PLANNING REPORT

PLANNING AND ZONING COMMISSION

3. Ohio Health Campus 09-092AFDP

7450 Hospital Drive Amended Final Development Plan

PROPOSED SIGNS FOR MOB

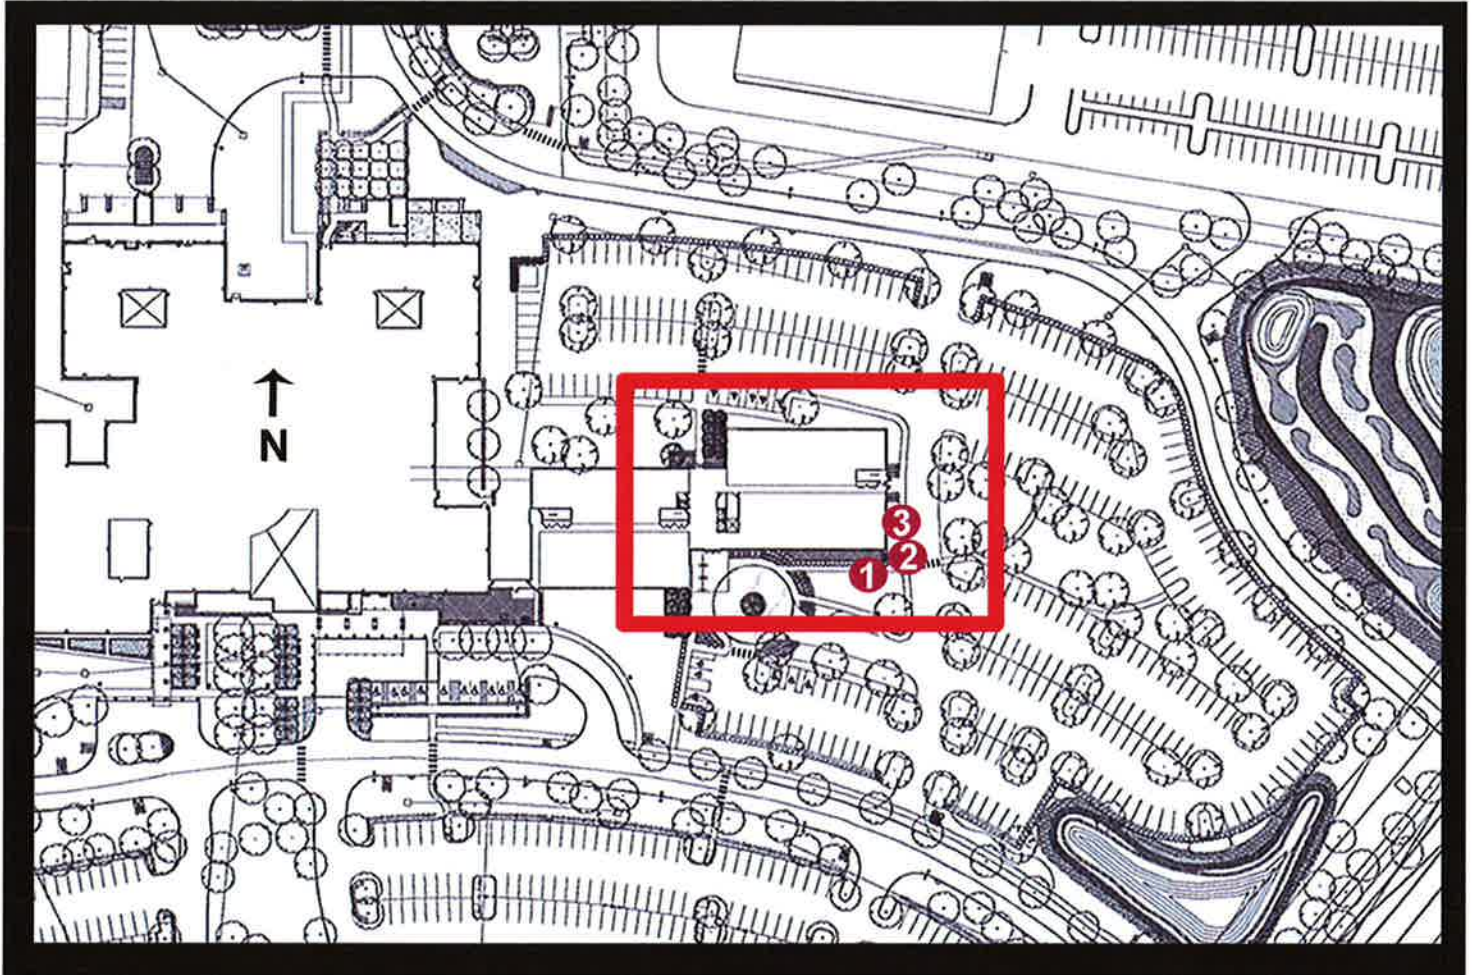
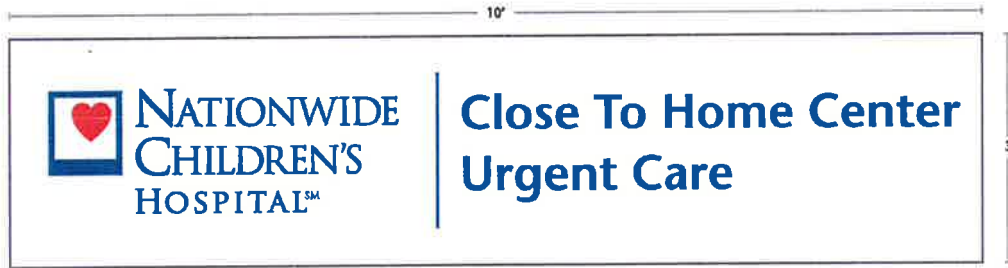
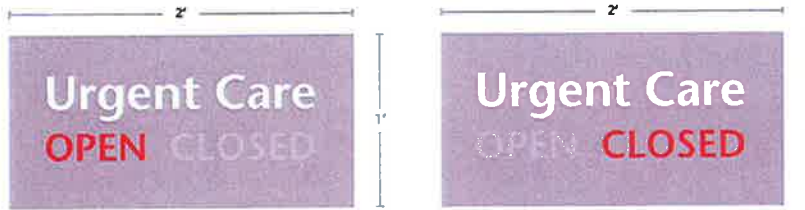
Below the tenant’s name is information indicating when the facility is open or closed. The words “Open” and “Closed” are routed white acrylic letters, backlit in red to describe the status of the facility. The objective of the sign is to direct patients to the Emergency Room if the Urgent Care is not open. Planning would recommend that the backlight used to emphasize “Open” or “Closed” be white to coordinate with the tenant name and limit the color red to the logo.

Criteria met. The proposed modifications do not impede the natural characteristics of the site and are in keeping with the overall appearance. Planning recommends that the back light used for the wall sign for the Urgent Care, emphasizing "Open" or "Closed" be white to coordinate with the tenant's name (Condition 2) and that other tenants not be permitted signs on the exterior of the building unless specifically approved by the Planning and Zoning Commission (Condition 3).

1. An updated master sign plan be submitted to the City of Dublin prior to the approval of sign permits.
2. The back light used for the wall sign for the Urgent Care, emphasizing “Open” or “Closed” be white to coordinate with the tenant’s name; and
3. That any other tenants not be permitted signs on the exterior of the building unless specifically approved by the Planning and Zoning Commission.

PROPOSED BUILDING MODIFICATION

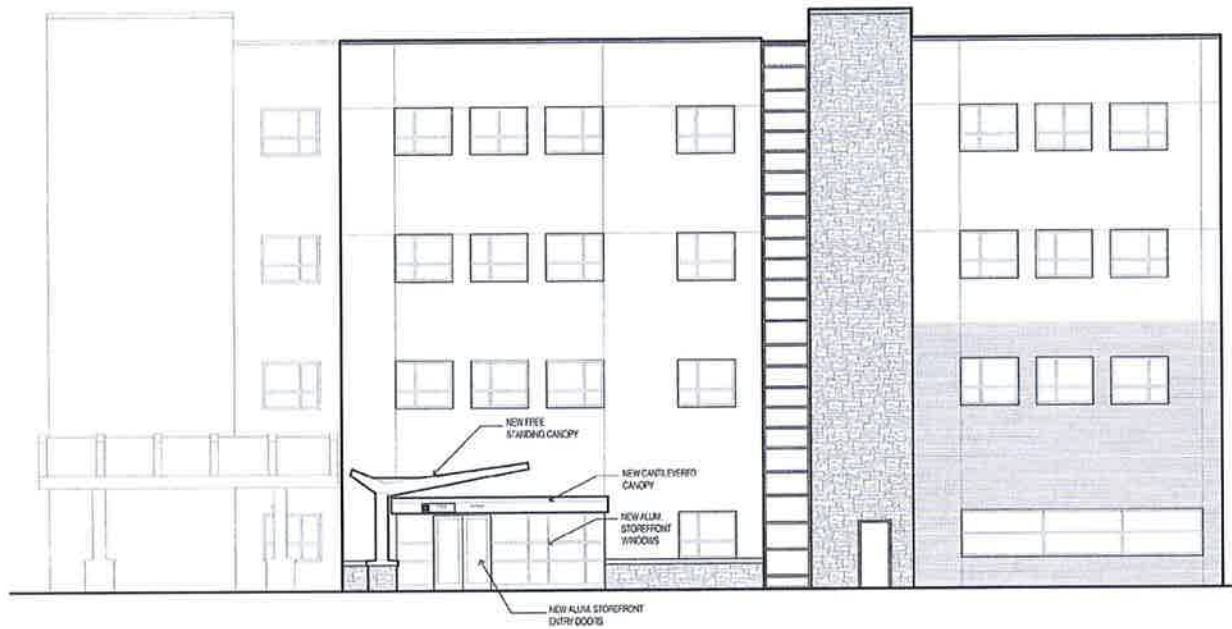
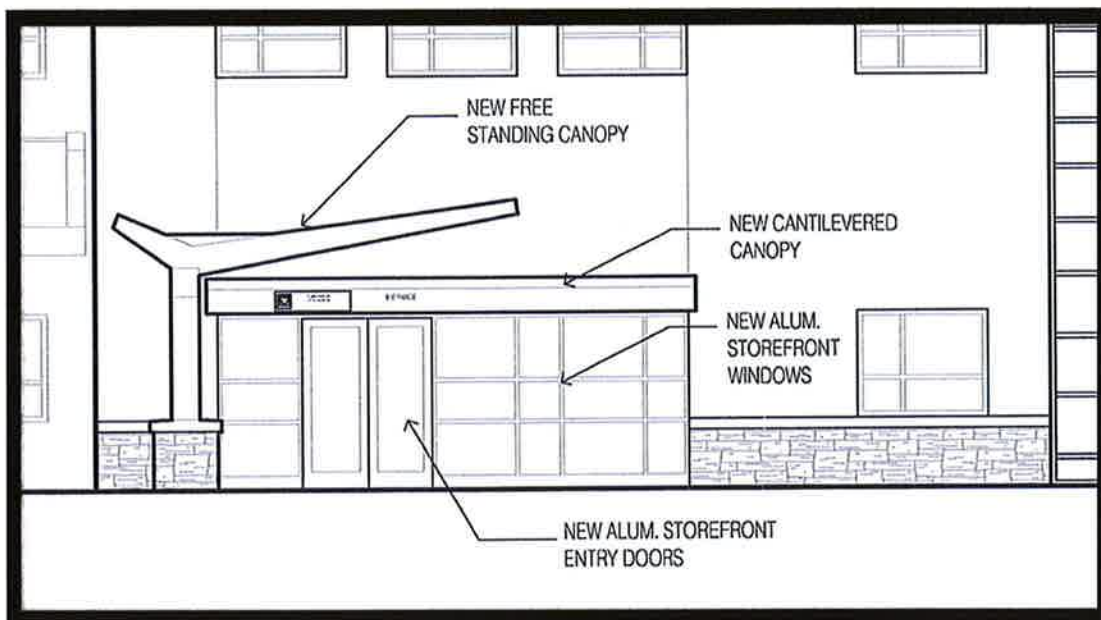
The text states that the architecture is urban in nature, but reflects the residential tones typically associated with development in the City of Dublin. The scale and style of the facades vary from residential to contemporary and create a noticeable presence in the community. Glass and natural finish materials are important part of the architectural style of the building and attempt to integrate nature from the exterior to the interior. The proposed entranceway will expand on these architectural themes by using the same materials found throughout the building. The proposed doorway will be an aluminum frame with clear vision glass. The entranceway replaces three existing windows.

The proposed cantilevered canopy will have a wall sign (described above) that identifies the entrance of the Nationwide Children’s Hospital. The entranceway will be further emphasized by a freestanding canopy that will consist of a metal, linear arch with a natural stone base. The canopy is consistent with other architectural elements of the building’s entrances and will provide additional dimension to the building.
